Application for Planning Approval

DA2025/011

10 SILVERGUM STREET, BRIGHTON

MULTIPLE DWELLINGS (2 UNITS)

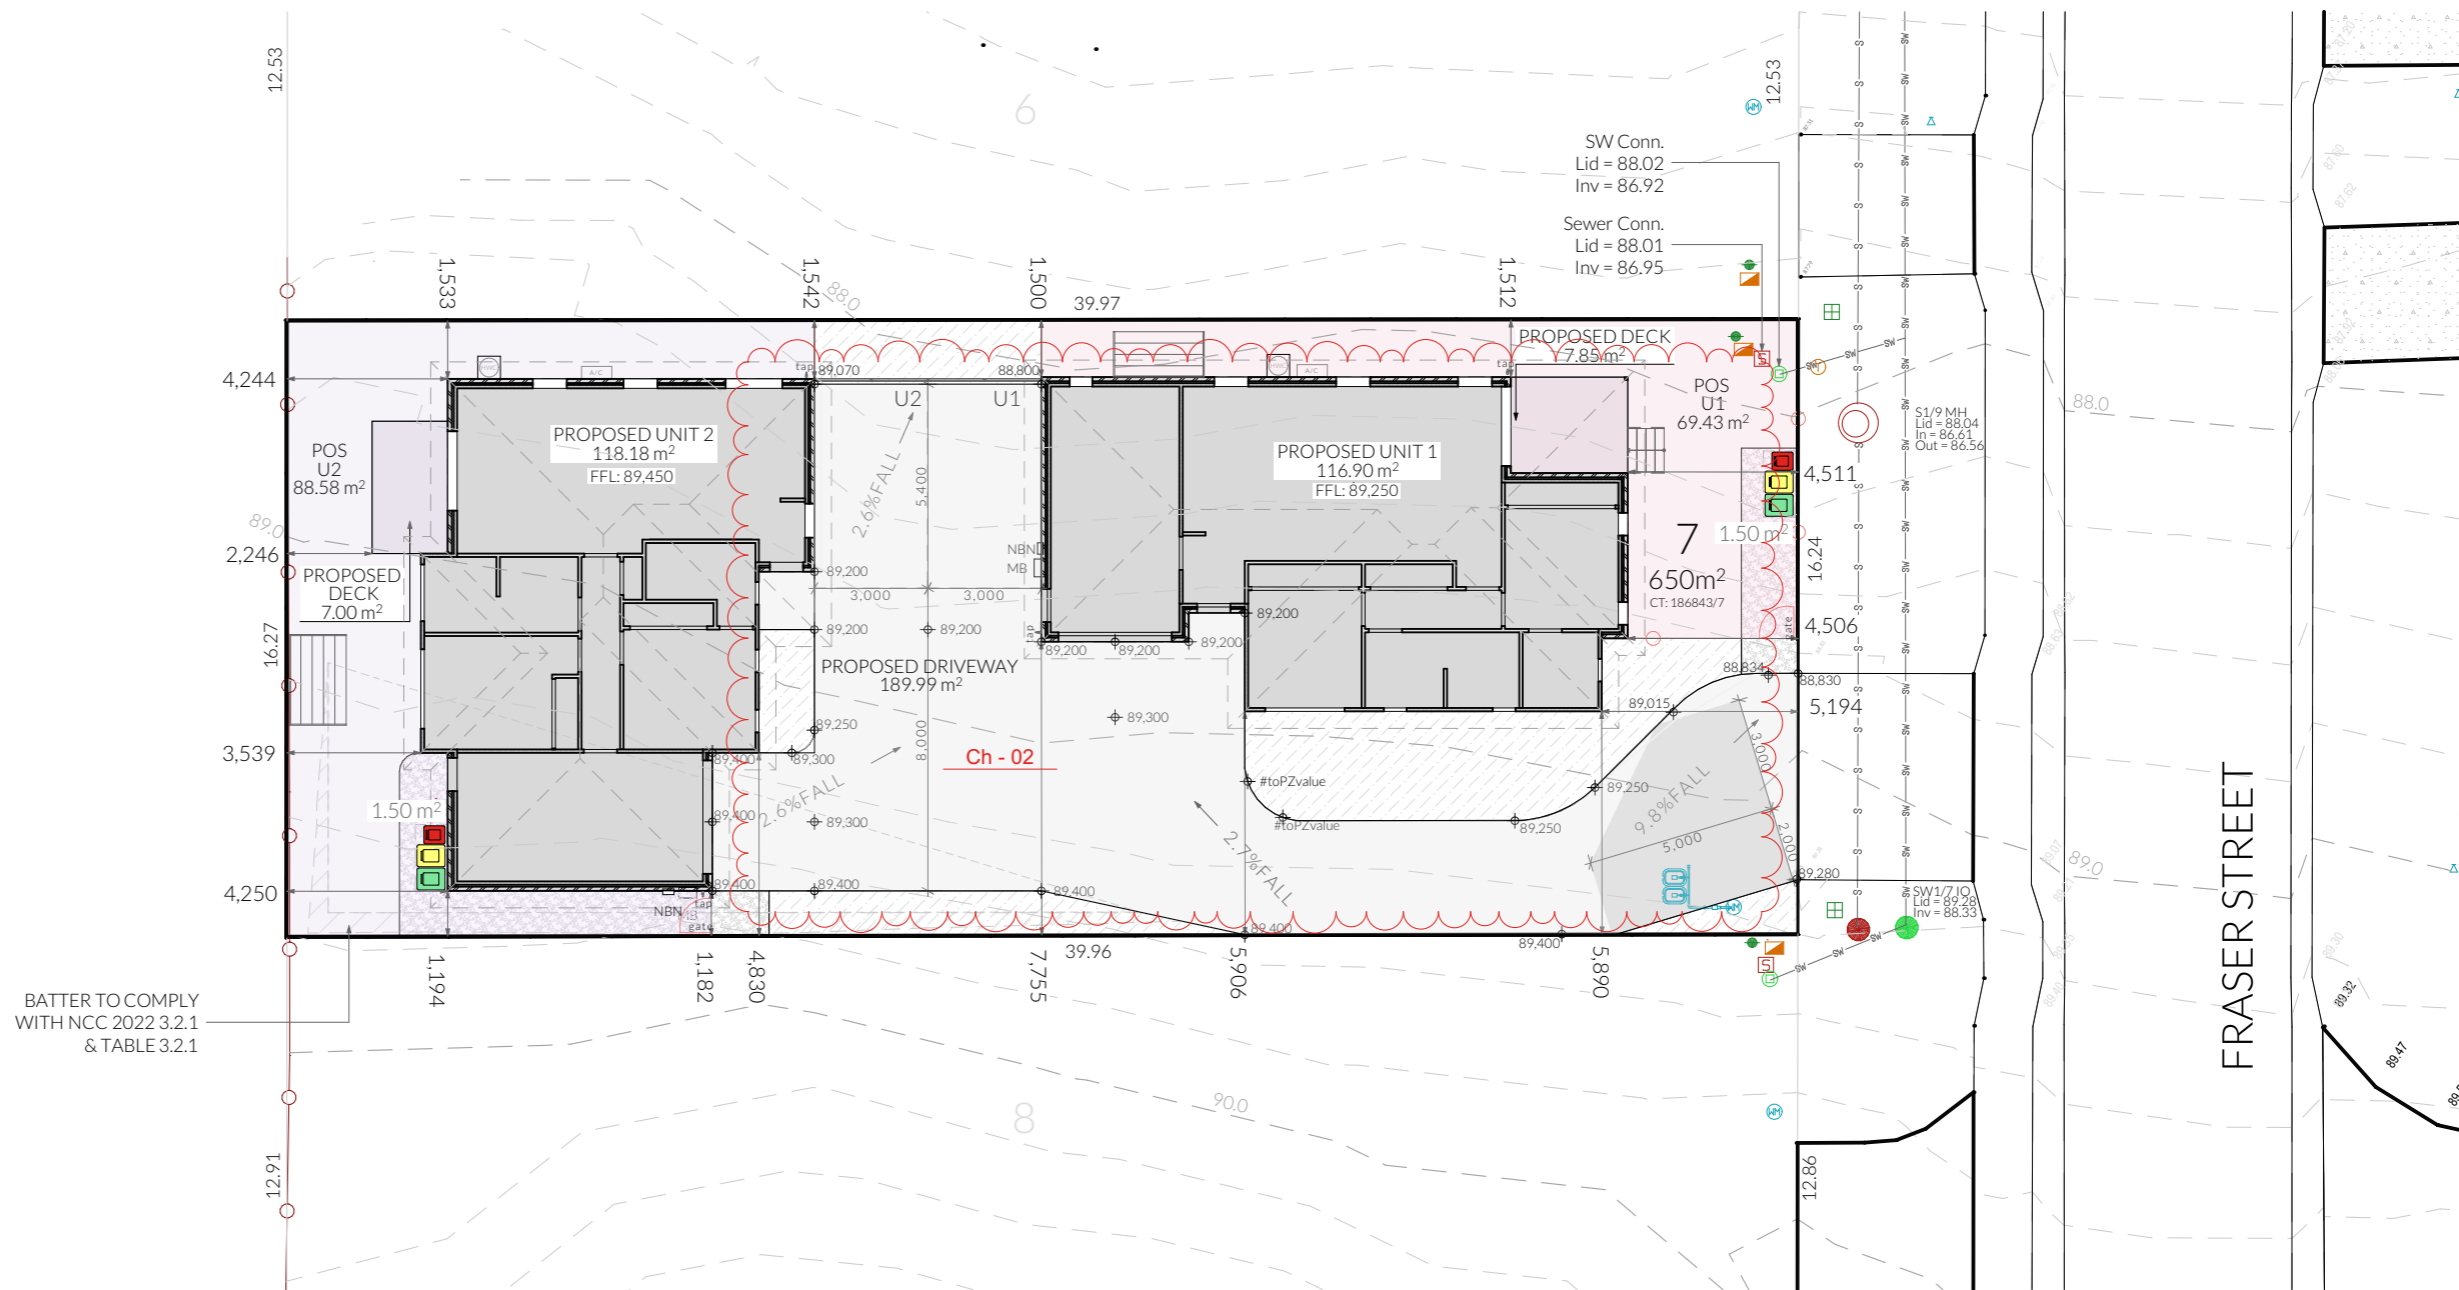
The design proposes a driveway layout that appears to create turning conflicts. Municipal engineer commented that the provided manoeuvring is not fully achievable in a safe and convenient way, Please provide a revised plan set that's shows a passing bay at the front, manoeuvring along the access, has turning sweeps that have adequate clearance to all constructed features and meets the requirements of Clause C2.6.2.A1.1 or demonstrate compliance with the Performance Criteria P1

- (i) **As shown on the site plan (A0.01) gradients for car spaces are less than 5% or 1:20. The maximum gradient for the access way is 9.8% which complies with the Australian Standards.**

Civil Plan
 Revision: DA - 02
 Approved by: JRN

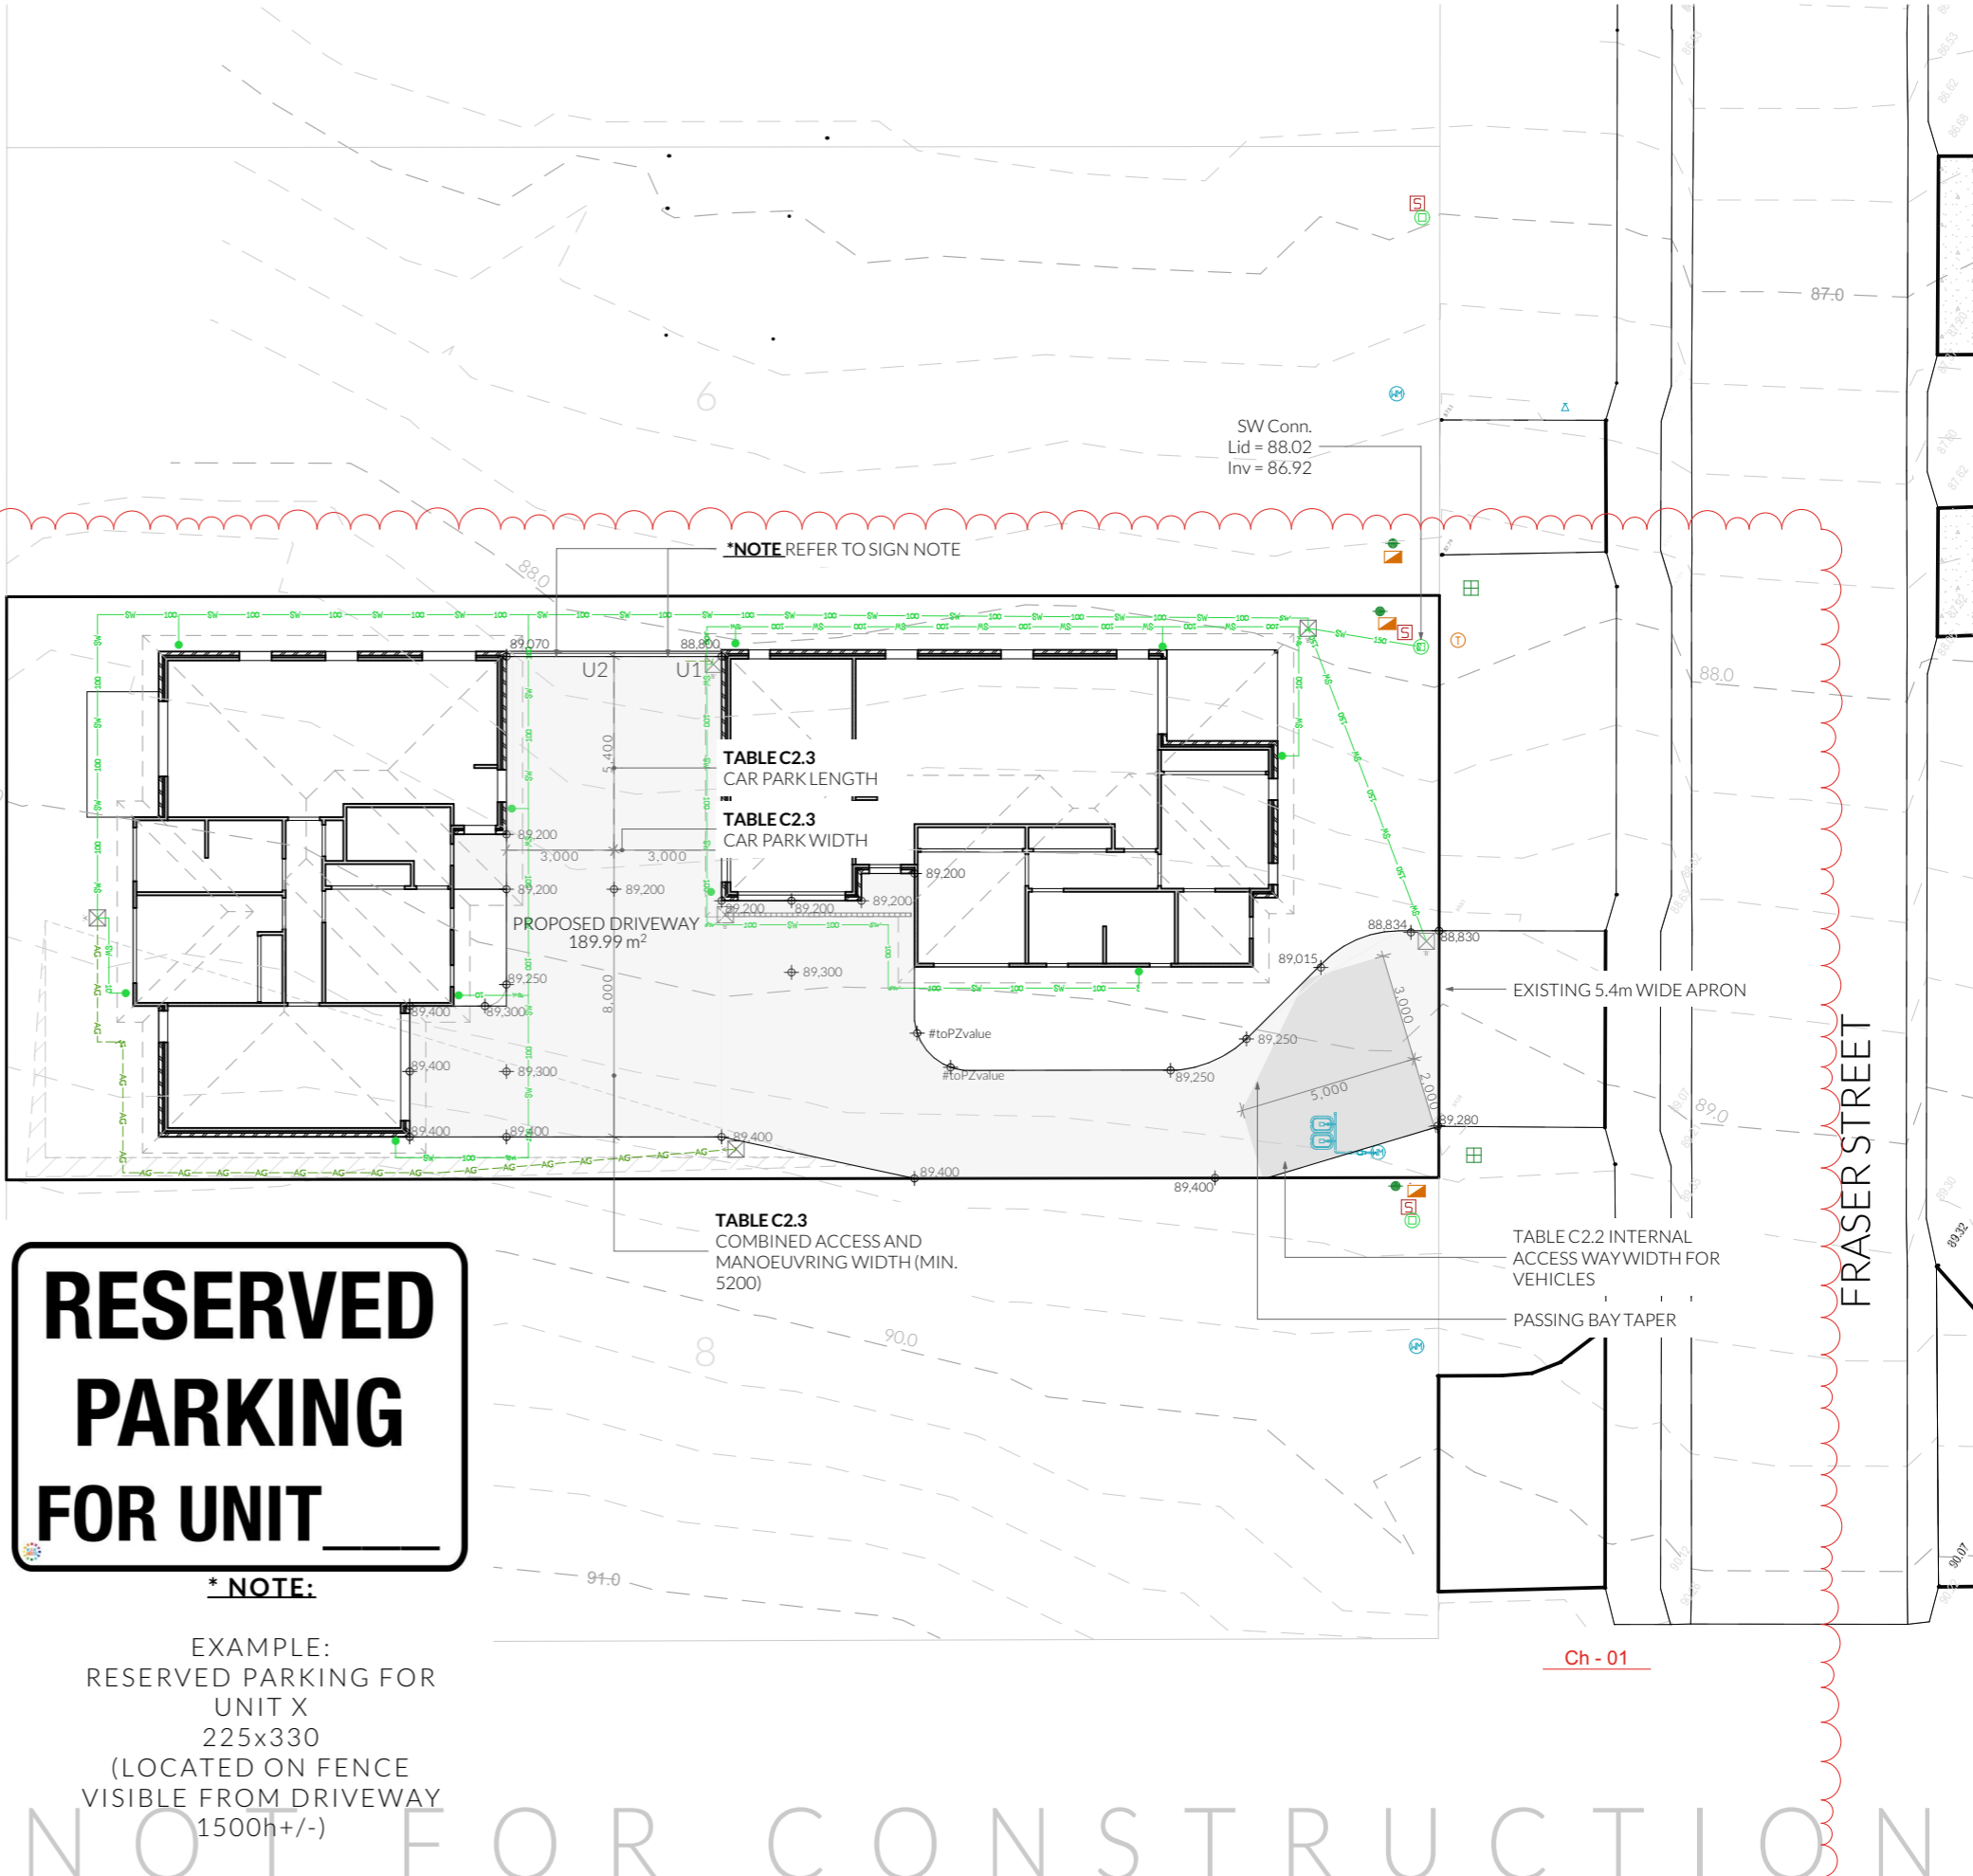
2 *In accordance with Clause C2.6.2 – Design and layout of parking areas*

- (iii) have an access width not less than the requirements in Table C2.2; **please refer to the fills on the civil plan C.01 showing the internal access way width of 3m + the 2m wide x 5m long passing bay for two way traffic**

- (iv) have car parking space dimensions which satisfy the requirements in Table C2.3; **please refer to the dimensions on the civil plan C.01 showing two compliant 3 x 5.4m car spaces**

- (v) have a combined access and manoeuvring width adjacent to parking spaces not less than the requirements in Table C2.3 where there are 3 or more car parking spaces; **please refer to civil plan C.01 showing 8m behind the parking spaces for manoeuvring**

carparks will be clearly labelled with the provided signage show on civil plan C.01
